Access Compliance Report

Public Rights-of-Way

(Island Curb Cuts)

Intersection ID: 15460	Main Street: CLANTON_RD	Cross Street: S_I-77_TO_CLANTON_RD_RA_SB	Location: S
ADA ID: 5B47482906F9	Curb Cut Type: IslandRefuge3	Initial Pass/Fail: Fail	Overall Compliance: No
		Severity Score: 36.25

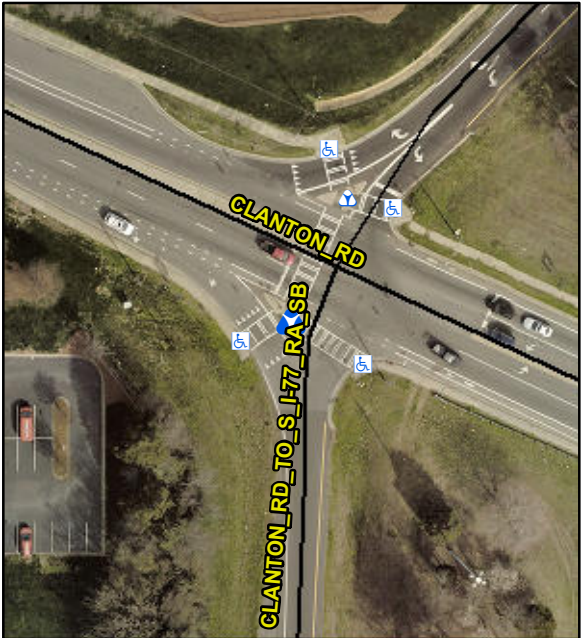
Codes/Mitigation Info/Possible Solution			Field Measurements/Component Compliance			
	Possible Solutions:		Compliance	Description	Data	
	Remove & Replace Entire Refuge.		Yes	Refuge 1 Length (In)	91.0	N/A
			Yes	Refuge 1 Width (In)	60.0	N/A
			Yes	Refuge 1 Slope (%)	4.2	N/A
			Yes	Refuge 1 X Slope (%)	4.1	N/A
			N/A	Painted X Walk1?	Yes	N/A
			N/A	X Walk 1 Direction	To SE	N/A
			N/A	X Walk 1 Width (In)	109.0	N/A
			N/A	Road 1 Slope (%)	4.7	N/A
			N/A	Road 1 X Slope (%)	3.0	N/A
<p>Surveyor Notes:</p> <p>N/A</p>			Yes	Refuge 2 Length (In)	70.0	N/A
			Yes	Refuge 2 Width (In)	60.0	N/A
			Yes	Refuge 2 Slope (%)	4.3	N/A
			Yes	Refuge 2 X Slope (%)	2.1	N/A
			N/A	Painted X Walk2?	Yes	N/A
			N/A	X Walk 2 Direction	To NE	N/A
			N/A	X Walk 2 Width (In)	110.5	N/A
			N/A	Road 2 Slope (%)	2.1	N/A
			N/A	Road 2 X Slope (%)	1.0	N/A
			Yes	Refuge 3 Length (in)	64.0	N/A
<p>PROW/ADA:</p> <p>N/A</p>			Yes	Refuge 3 Width (in)	60.0	N/A

Yes	Refuge 3 Slope (%)	2.1	N/A
			Yes	Refuge 3 XSlope (%)	0.1	N/A
			N/A	Painted X Walk3?	Yes	N/A
			N/A	X Walk 3 Direction	To SW	N/A
			N/A	X Walk 3 Width (in)	112.0	N/A
			N/A	Road 3 Slope (%)	0.4	N/A
			N/A	Road 3 XSlope (%)	3.2	N/A
			Yes	Any Obstructions?	N/A	N/A
			N/A	Obstruction Type	N/A	N/A
<p>Total Cost:</p> <p>\$ 3000.00</p>			N/A	Surface Condition	Good	N/A
